File No. LDA12-0310

RE: Tentative plan of subdivision to create 203 single detached residential lots, 106 semi-detached residential lots, 56 row house residential lots, two (2) multiple family lots, two (2) Municipal Reserve lots, and three (3) Public Utility lots from NE 31-51-23-4, Lot 1, Block C, Plan 082 0895 and Lot A, Plan 5736RS located west of 17 Street NW and south of 23 Avenue NW; **LAUREL**

I The Subdivision by Plan is APPROVED on September 5, 2013 subject to the following conditions:

SUBDIVISION CONDITIONS OF APPROVAL MAP

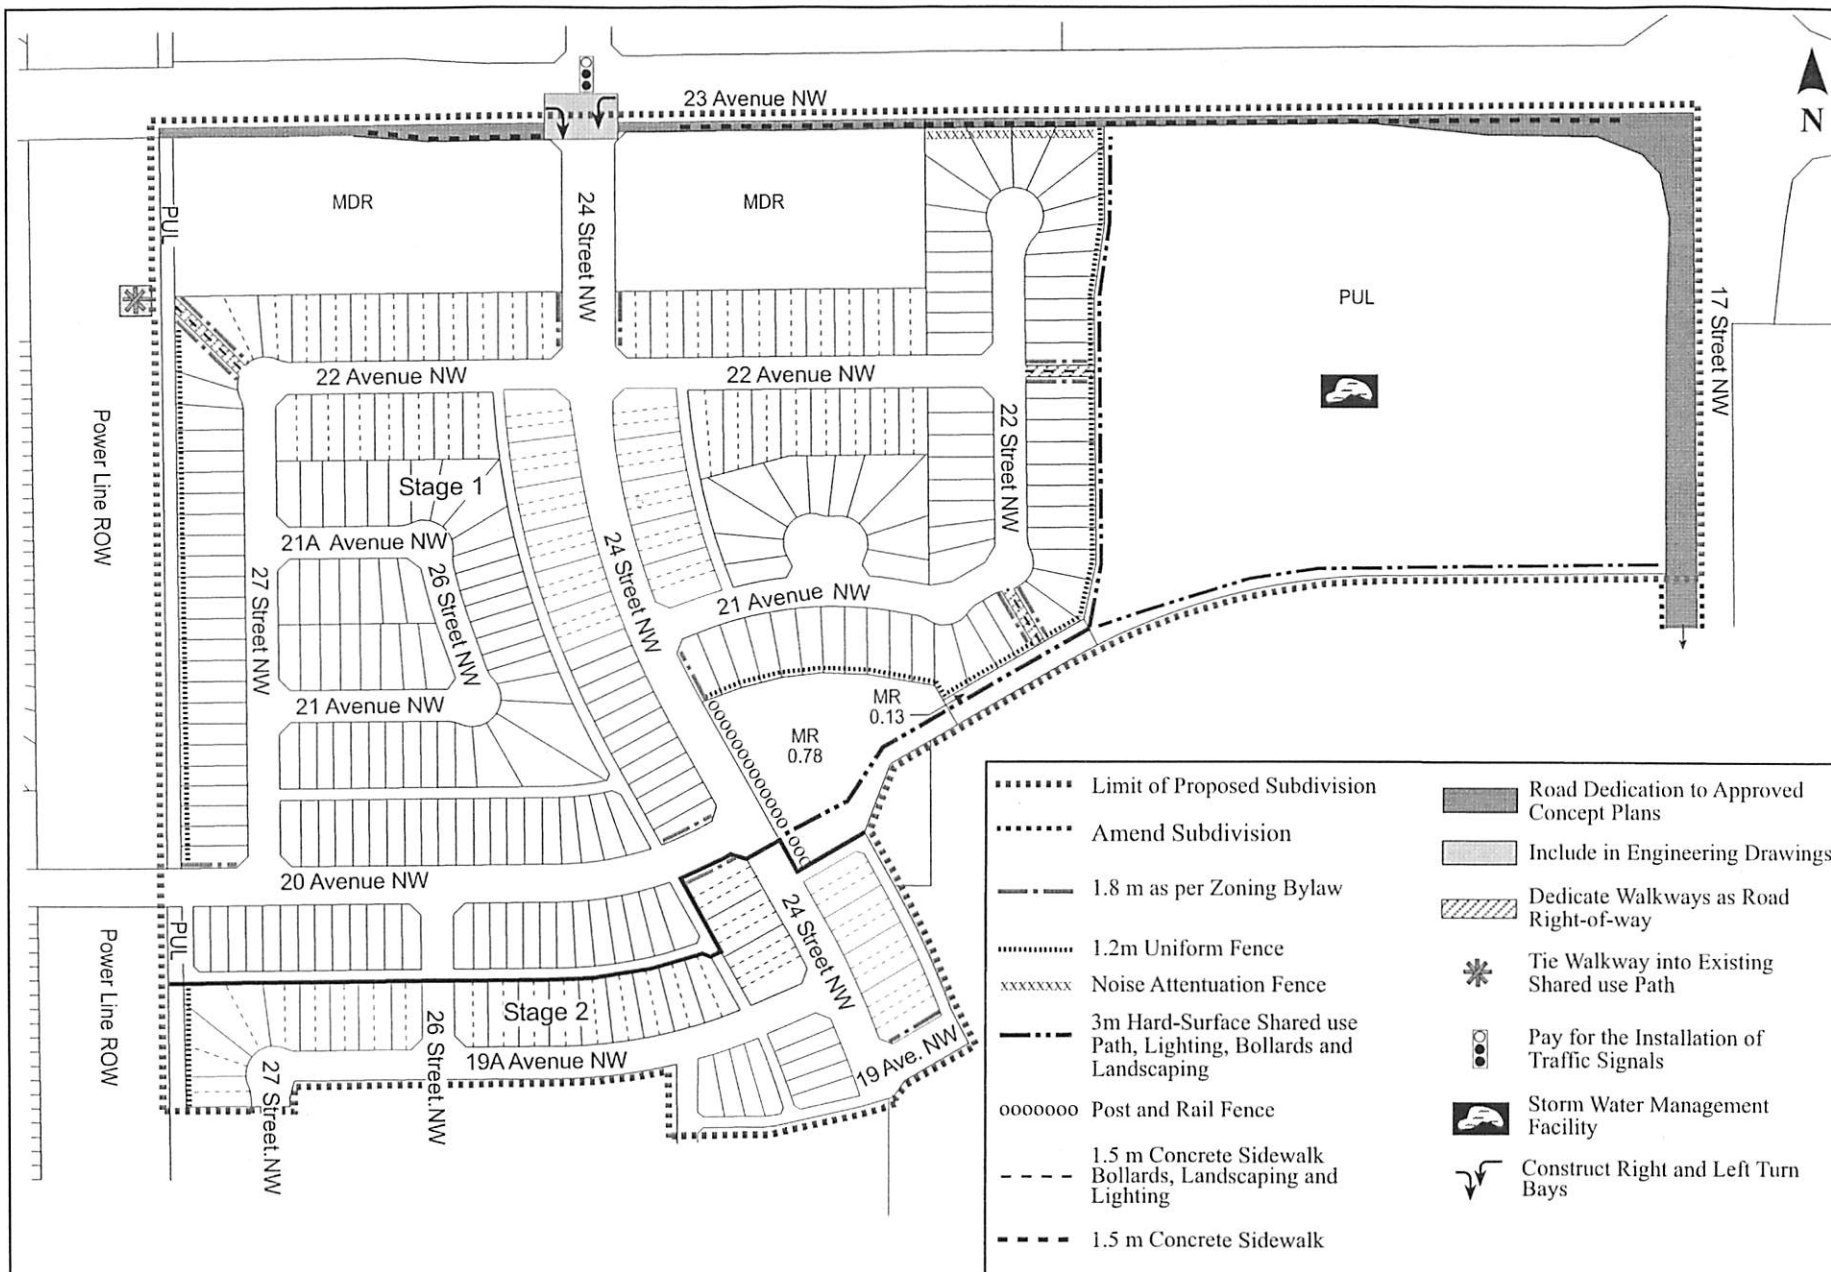
1. that the owner dedicate Municipal Reserve as a 0.78 ha parcel and a 0.13 ha parcel pursuant to Section 666 of the Municipal Government Act as shown on the "Conditions of Approval" map, Enclosure I;

5. that the owner dedicate road right-of-way to conform to an approved Concept Plan or to the satisfaction of Transportation Services for 23 Avenue NW, as shown on the "Conditions of Approval" map, Enclosures I and II;

6. that the subdivision boundary be amended to include the dedication of the 17 Street road right-of-way to conform to an approved Concept Plan, to the satisfaction of Transportation Services, as shown on the "Conditions of Approval" map, Enclosures I and II;

7. that the owner be permitted to register this plan of subdivision in stages, as shown on the "Conditions of Approval" map, Enclosure I, at the discretion of the Chief Subdivision Officer, having regard to the provision of roadways and the logical extension of services;

8. that the owner provide all walkways as road right-of-way as shown on the "Conditions of Approval" map, Enclosure I; and
9. that the owner pay all outstanding property taxes prior to the endorsement of the plan of subdivision.

11. that the engineering drawings include the right and left turn bays on 23 Avenue for 24 Street NW, to the satisfaction of Transportation Services as shown on the "Conditions of Approval" map, Enclosure I;

12. that the owner pay for the installation of traffic signals at the intersection of 23 Avenue and 24 Street, as shown on the "Conditions of Approval" map, Enclosure I. The City of Edmonton shall complete the signal design, and the City's Electrical Services Contractor must install the signal as per the agreement between the City of Edmonton and the Electrical Services Contractor. If the timing of the traffic signals are not deemed warranted by Transportation Services within 5 years of the signing of the Servicing Agreement, the owner will be required to provide payment to the City of Edmonton for the installation of traffic signals at that time to fulfill this obligation;

13. that the owner construct a 3.0 m hard-surface shared use path with a dividing yellow centerline and "Shared Use" signage, lighting, bollards and landscaping, to the satisfaction of Sustainable Development and Transportation Services, as shown on the "Conditions of Approval" map, Enclosure I;

14. that the owner construct additional features, including but not limited to, park furniture (e.g. benches, garbage receptacles), trees and shrub beds, and directional and interpretive signage, within the 0.13 ha MR parcel, in accordance with the Laurel NSP, to the satisfaction of Sustainable Development, as shown on the "Conditions of Approval" map, Enclosure I;

15. that the owner construct 1.5m concrete sidewalks with bollards, lighting and landscaping, to the satisfaction of Transportation Services, in the locations as shown on the "Conditions of Approval" map, Enclosure I;

16. that the engineering drawings include tying the walkway connection to the Shared Use Path, to the satisfaction of Transportation Services, as shown on the "Conditions of Approval" map, Enclosure I;

17. that the owner construct 1.5m concrete sidewalks along the south side of 23 Avenue from the existing bus stop to 17 Street NW, in the locations as shown on the "Conditions of Approval" map, Enclosure I.

18. that the owner construct a noise attenuation fence as per the City of Edmonton Roadway Design Standards Drawing #5205, to the satisfaction of Transportation Services, in the location as shown on the "Conditions of Approval" map, Enclosure I;

19. that the owner construct all fences positioned wholly on privately-owned lands, and the post and rail fence on the MR parcel, to the satisfaction of the Sustainable Development, Transportation Services and Financial Services and Utilities in the locations as shown on the "Conditions of Approval" map, Enclosure I; and
